**STAFF RECOMMENDATION**

**1410 Dallas Avenue**

**February 17, 2021**

**Description of Project:** Application for the construction of a rear addition that steps wider on one side.

Figure 3. Right side: existing addition steps wider

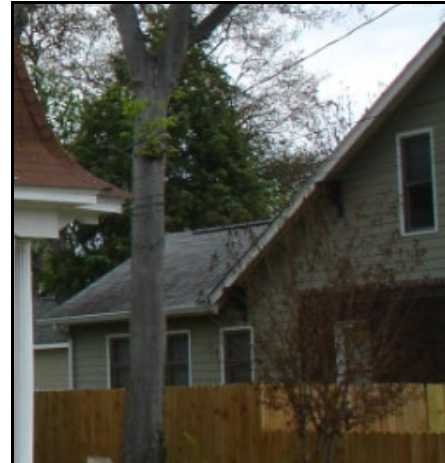
The new addition will not step any wider than the existing addition on the right side. Here, the existing addition steps five feet (5') wider than the main body of the historic house (Figure 3) On the first level, the addition will be inset slightly (about one foot (1')) to avoid any setback issues. Because there is an existing addition, the applicant is not required to provide an inset at this corner.

Figure 7. Left side elevation.

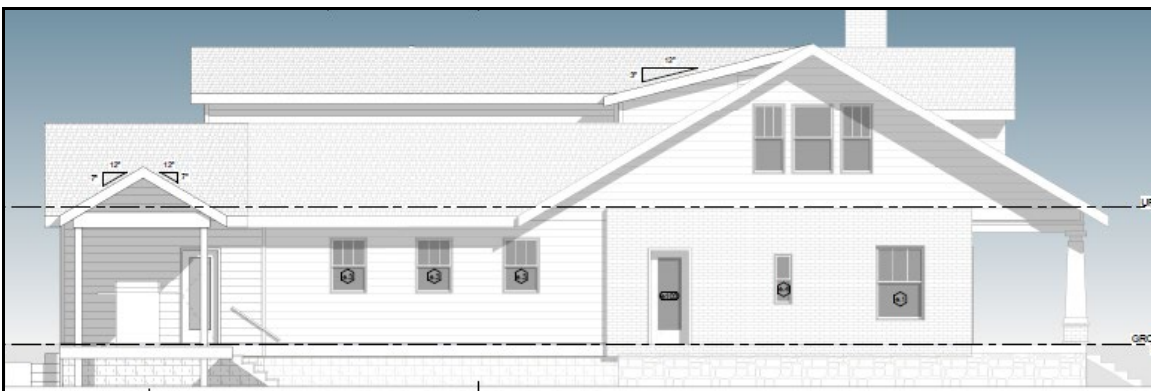
Roof form: The addition uses two rear-facing gables: one that has a 7/12 pitch and extends the existing one-story addition on the left side of the house and the second is 5/12 and is at the second level.

Proportion and Rhythm of Openings: As discussed above, there is currently a door on the front face of the wider previous addition, which will be removed. Otherwise, no changes to the window and door openings on the existing house were indicated on the plans. The windows on the proposed addition are generally twice as tall as they are wide, thereby meeting the historic proportions of openings. Two smaller square windows are

proposed for the second level on the left side. (Figure 8) Staff finds that these could be appropriate in this location as they are accent windows, not the dominant window form.

Figure 8. Right side elevation.

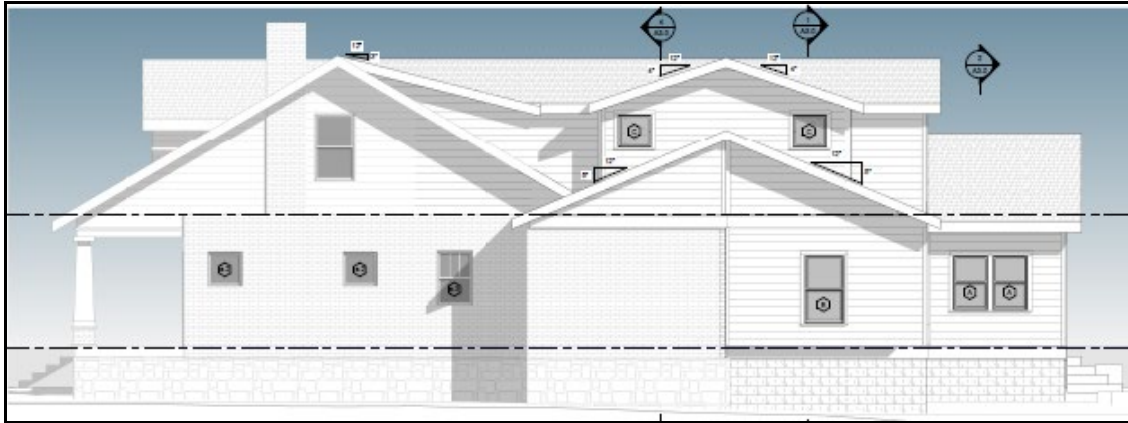
Where the old shed-roofed addition steps wider on the right side, the applicant proposes to alter the roof form, creating a 5/12 gable facing the side property line. (Figure 8) Another gable with a 4/12 pitch will extend above.

On the right-side elevation, there is a fifteen-foot (15') section of brick wall with no window. The guidelines recommend a window or door opening every eight to thirteen feet (8'-13'). Because this wall is existing, staff is not recommending a window be added to the masonry wall.
